BCM943362WCD6_3 Rev01

PC1 PCB NUMBER: 200-125211-0030 PCB NAME: BCM943362WCD6_3 ZH1 SCHEMATIC DIAGRAM

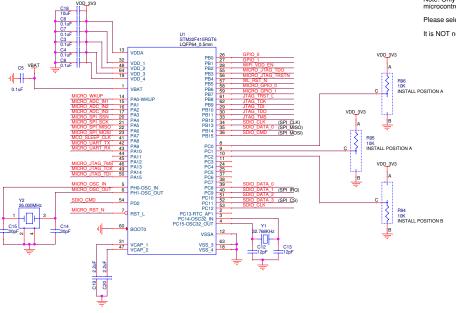
- 1) Added 10k resistors R94, R95, R96 for identifying board revision.
- 2) Renamed "32K_PWM_OUT" net to "MCO_SLEEP_CLK" and moved from using PA11 to PA8.

(Note: When using WICED Powersave API, it is critical that an accurate $32.768 \rm kHz$ clock is used for the sleep clock input pin of the WLAN chip.

The MCO1 pin (PA8) can be used to route out the highly accurate $32.768 \mathrm{kHz}$ LSE clock and is now used as the source for the sleep clock into the WLAN chip.

The LSE clock is more accurate than generating a PWM signal out of PA11.)
